TO: Old Orchard Beach Planning Board
FROM: Planning Staff
SUBJECT: September Planning Board Meeting Summary
DATE: 8 September 2016

Proposal: Major Subdivision and Site Plan: 40 unit condominium project
Action: Final Plan Review; Ruling
Owner: Church Street LLC
Location: 164 Saco Ave., MBL: 208-1-9, GB1 & R4

Proposal: Conditional Use, Subdivision Amendment; Site Plan Amendment: 6 unit condominium expansion (Summerwinds II)
Action: Preliminary Plan Review
Owner: Saulnier Development
Location: 180 Saco Ave., MBL: 208-1-1, GB1 & R4

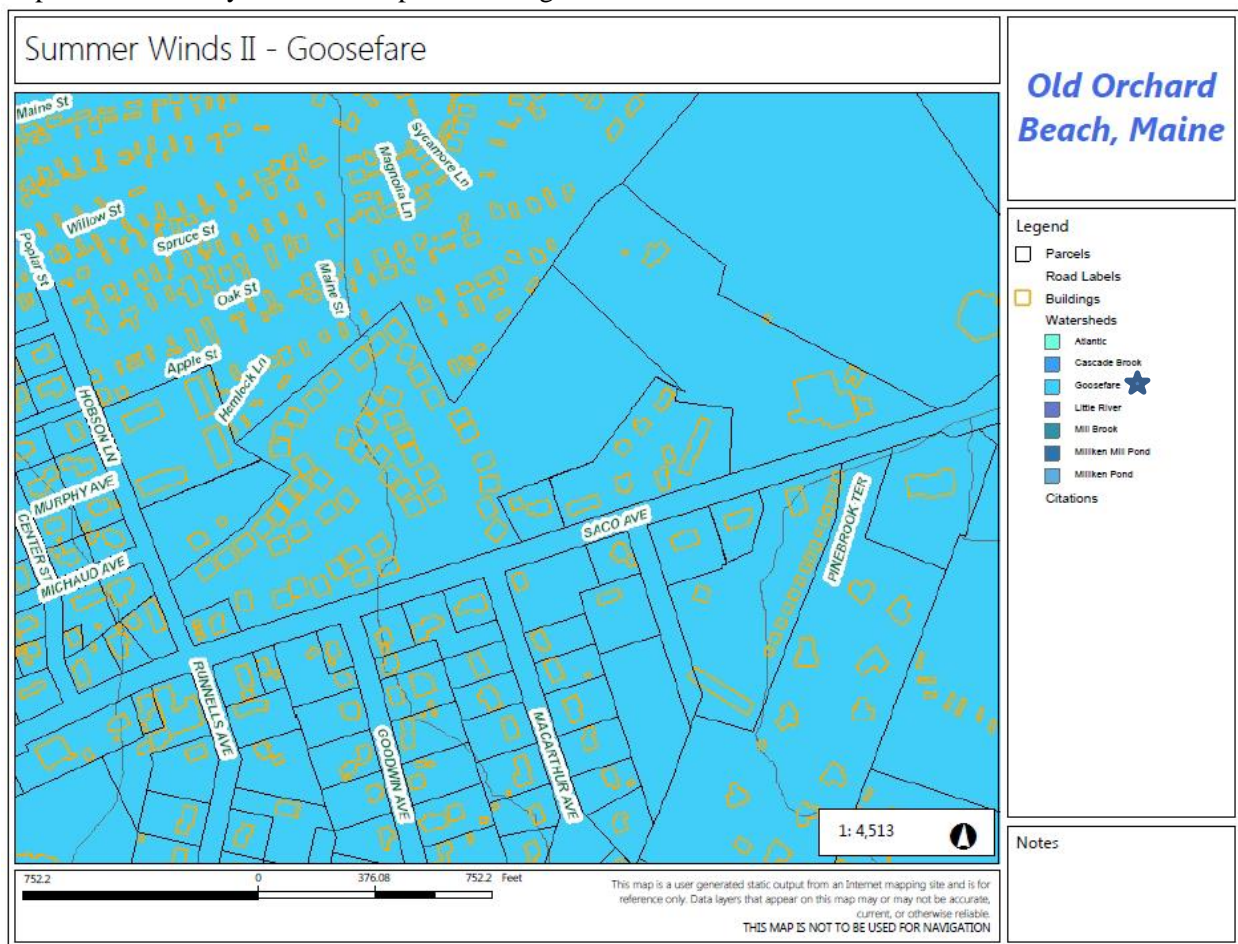
All underground utilities shall have a detectable warning tape above the utility.

Sidewalks should be handicap accessible.

Where the proposed drive connects to the existing access road, truck turning movements should be checked. They should check for both fire vehicles and moving vans.
